Choose the plate files to machine

A small, precise manufacturing set

Pro must choose which main/diverter plate variants should actually be made and return exact file-by-file instructions. Each manufacturing STEP must contain one custom plate solid. Keep wall, valve and assembly references outside the fabricator package. Specify filenames, dimensions, purpose, stock, quantities, isolated previews and verification. The six current standalone candidates are listed in 06_PLATE_ONLY_FILE_GUIDE.txt.

Inner plate measured face

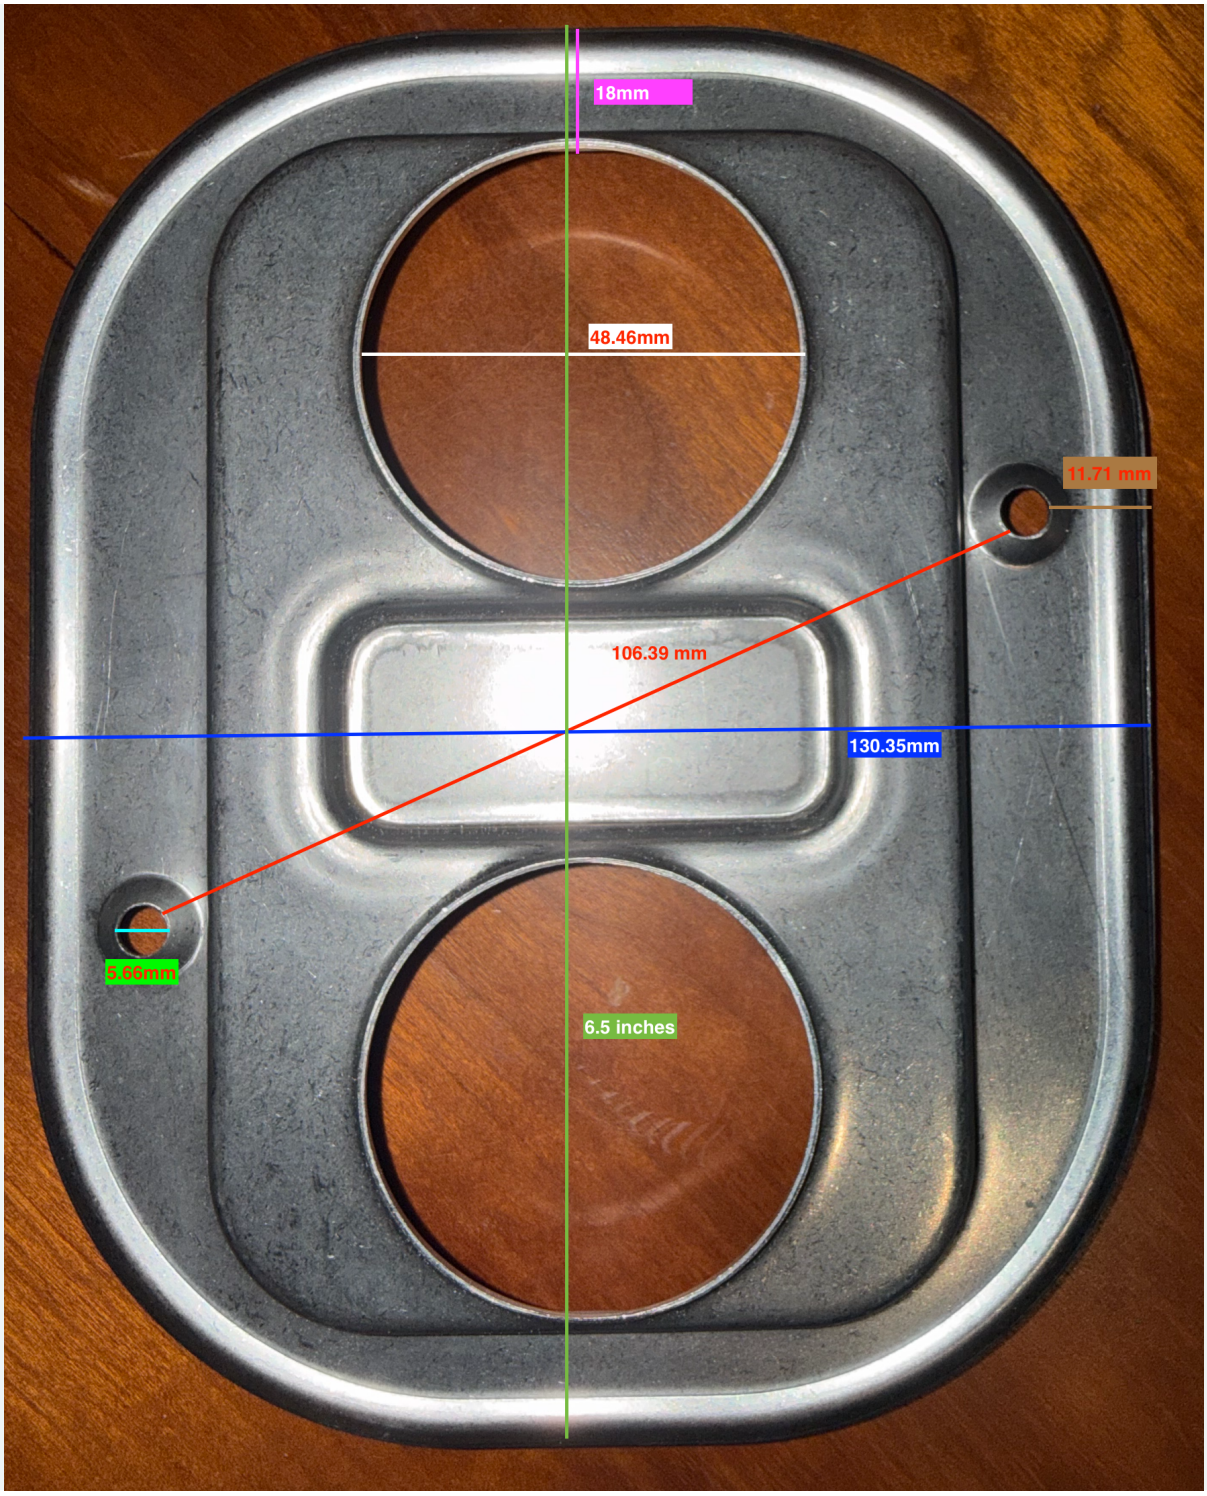
Measured within one plane; the owner considers the caliper readings highly accurate. No tip-depth correction applies. Width 130.35 mm; upper opening 48.46 mm; tape height 165.10 mm.

106.39 mm is nearest-hole-edge gap; 11.71 mm is hole edge to outside rim; SW hole is 5.66 mm; NE diameter is unknown. Use the calipers ahead of scan estimates for these measured dimensions. Foam/depth readings are separate; no numerical accuracy bound was supplied.

Decorative cover measured face

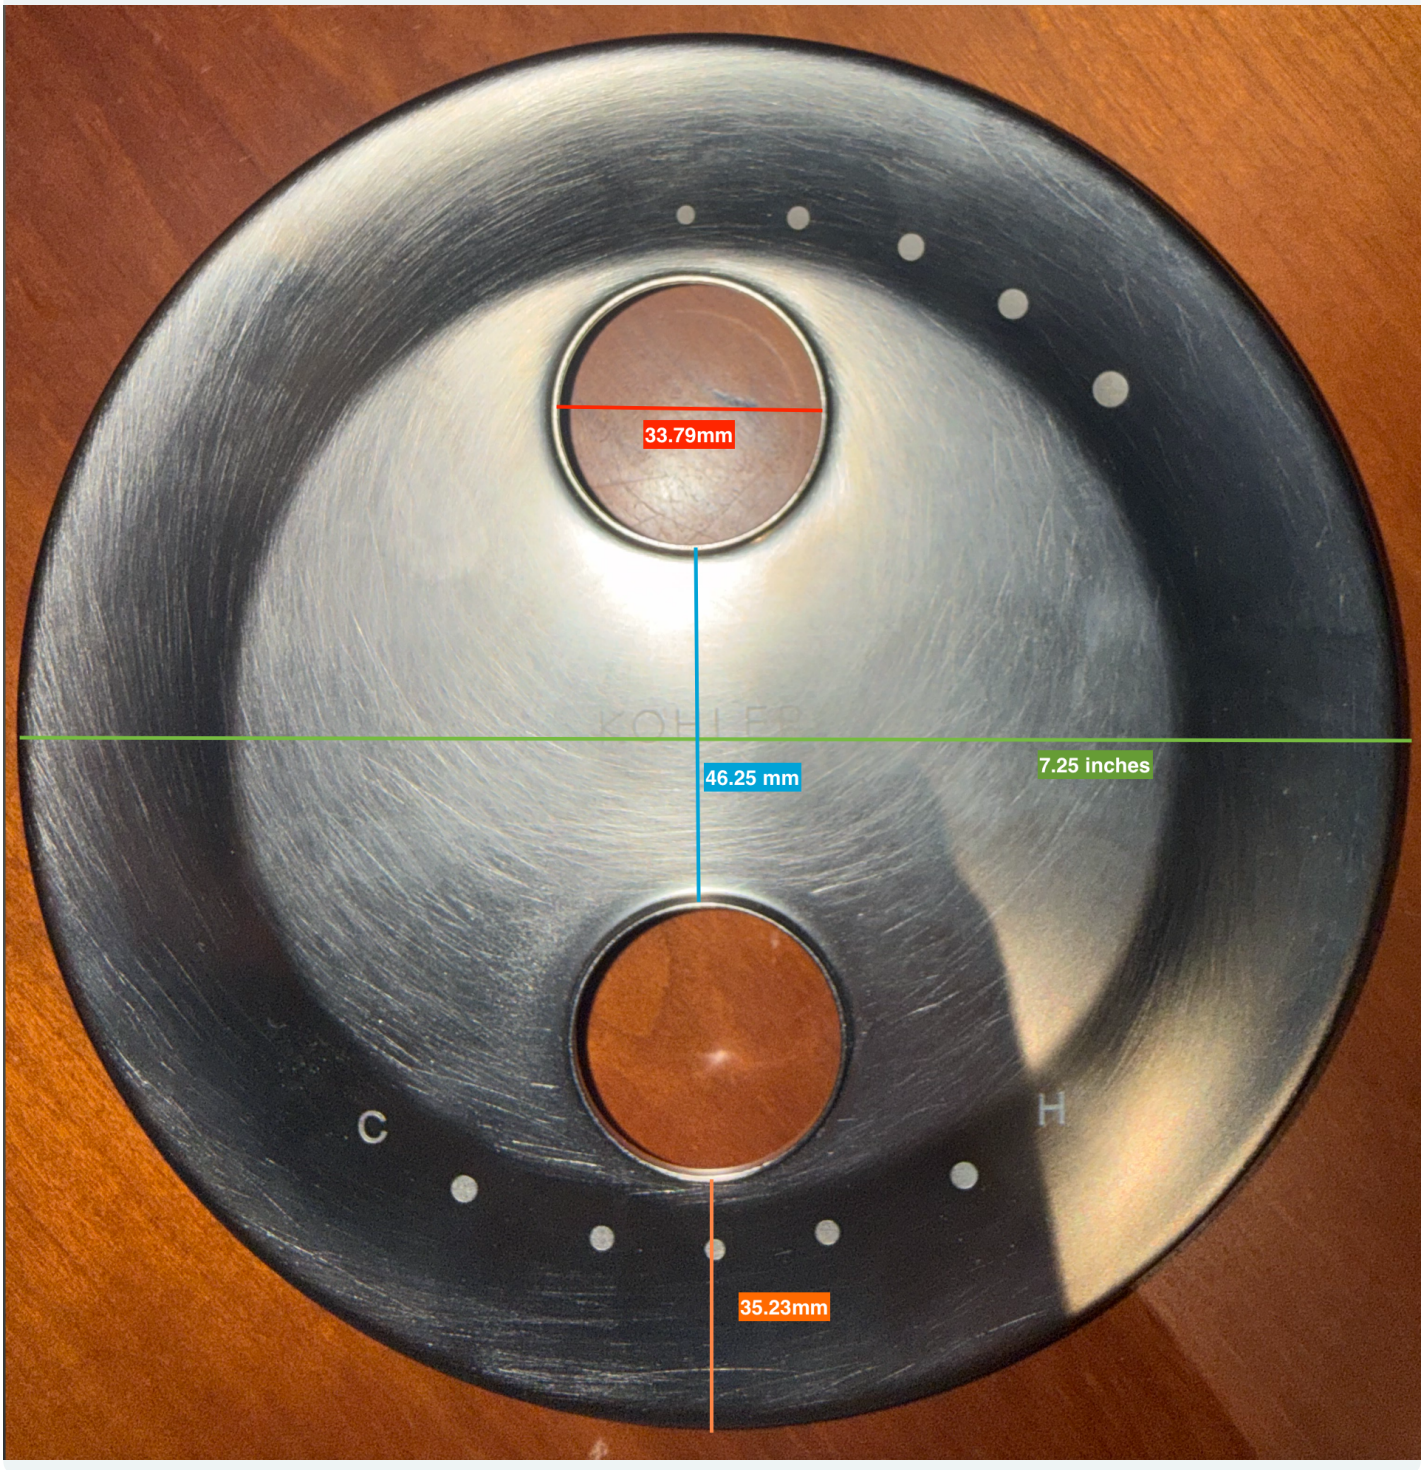
Outside diameter 7.25 inches = 184.15 mm. Upper opening 33.79 mm. The blue 46.25 mm is between nearest inside opening edges. Orange 35.23 mm runs from lower inside opening edge to outside bottom rim.

Lower opening diameter and rear cavity are unmeasured. These front dimensions do not establish nut clearance, handle engagement or the installed center.

Current main aperture

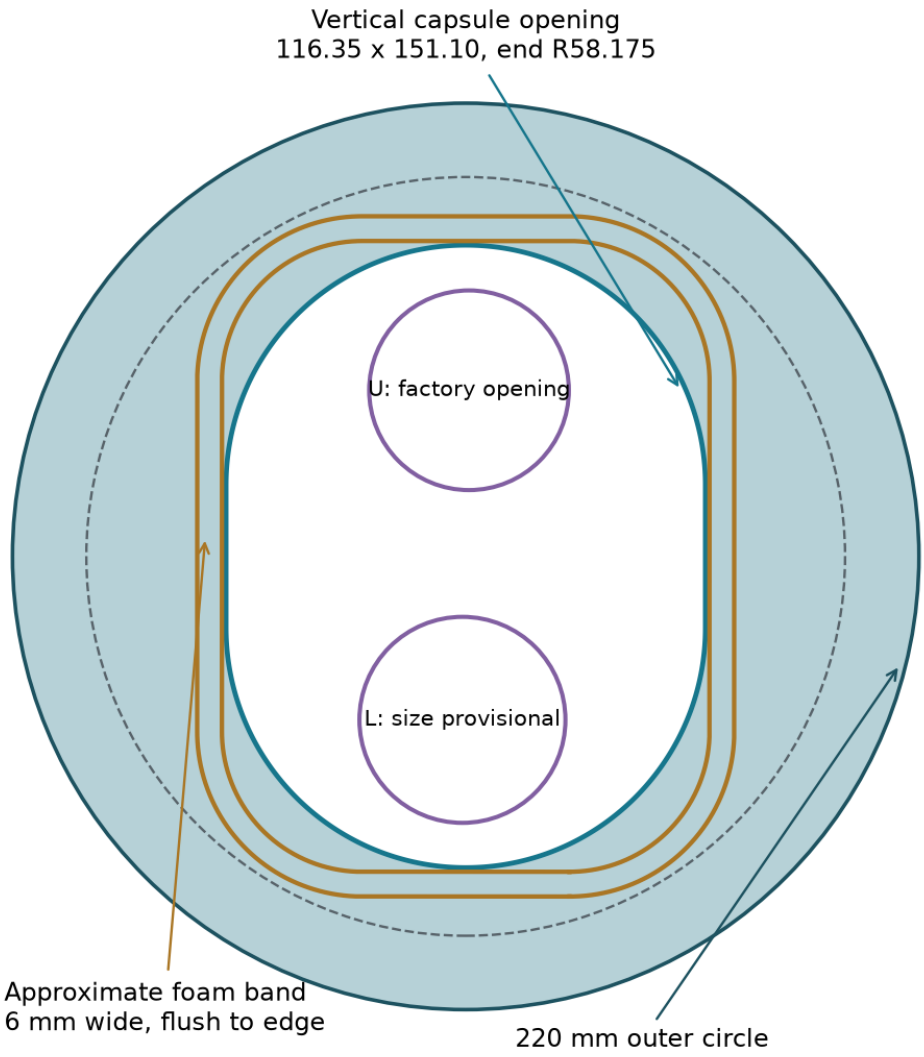
Gold is a nominal footprint, not a verified seal. 1.00 mm extra land inside the assumed foam.
Purple circles belong to the factory inner plate; they are not extra holes cut in this part.

Main outside diameter 220 mm; centered vertical capsule 116.35 x 151.10 mm with R58.175 ends. Gold represents assumed edge-flush foam. The lower opening circle and some placement dimensions remain assumptions.

The nominal extra land inside the 6 mm foam is only 1 mm. The smallest scoped projected hardware clearance is about 1.61 mm before unresolved scan/placement errors. These are review targets, not accepted field tolerances.

Main and diverter size choice

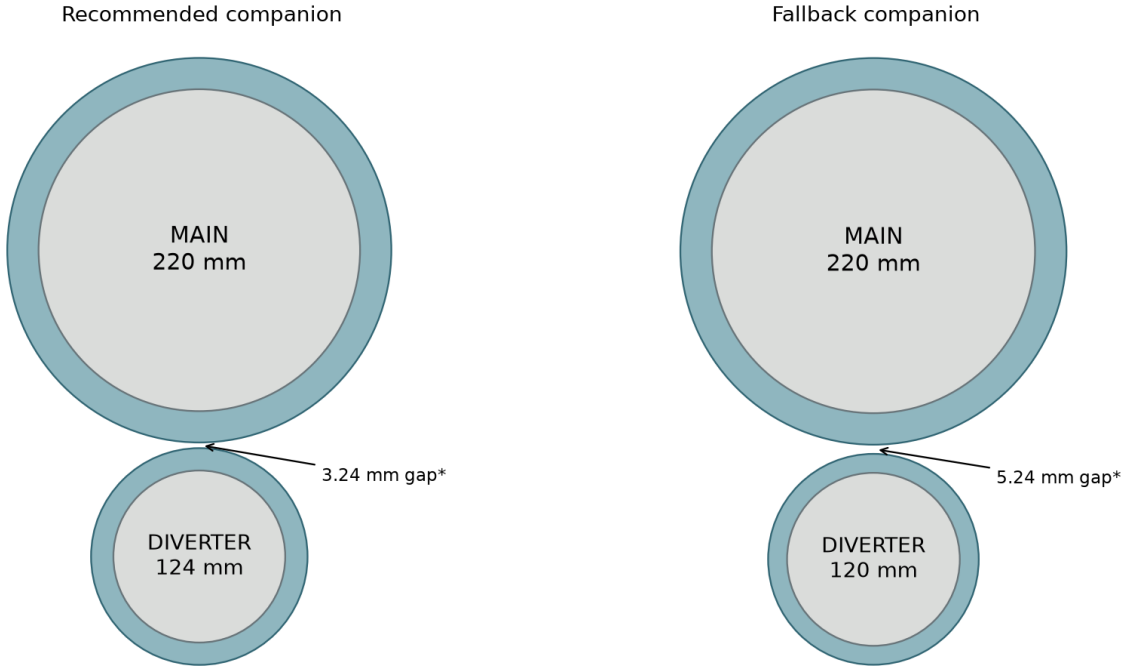
*Original placement estimate. Across recorded scenarios, selected-pair gap is 3.06-5.21 mm, not error bounds. Increasing either diameter consumes half that increase from the gap. Verify with both real covers.

Earlier placements predict only about 3-5 mm between the larger pair. These are scenarios, not an uncertainty range. The actual diverter seal footprint and paired clearance need the expert fit trial.

Recommended trial: main 220 mm and diverter 124/80 mm. The separate diverter fallback is 120/80 mm. Keep both backing circles concentric with their actual covers.

Earlier locating-tab experiment

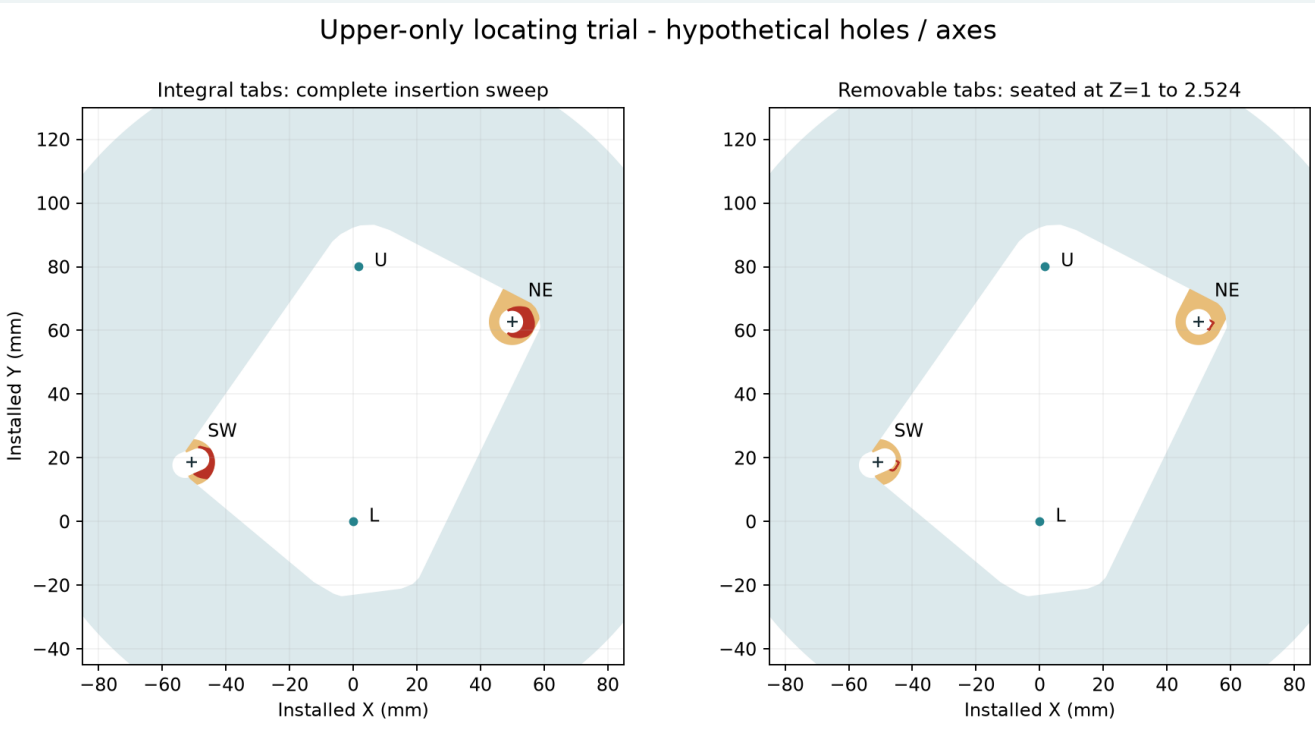
Amber: added tab metal. Red: projected captured-surface interference. Not a released mounting design.

This earlier diagonal opening added metal tabs with hypothetical holes/axes. Red marks conditional captured-surface interference in insertion or seated trials. It is not the FT01 capsule design.

The trial does not rule out every notch. A notch removes material; a tab adds it. Pro should independently assess restraint, adjustment, foam land, bearing, depth and complete insertion/removal before recommending a locator variant.
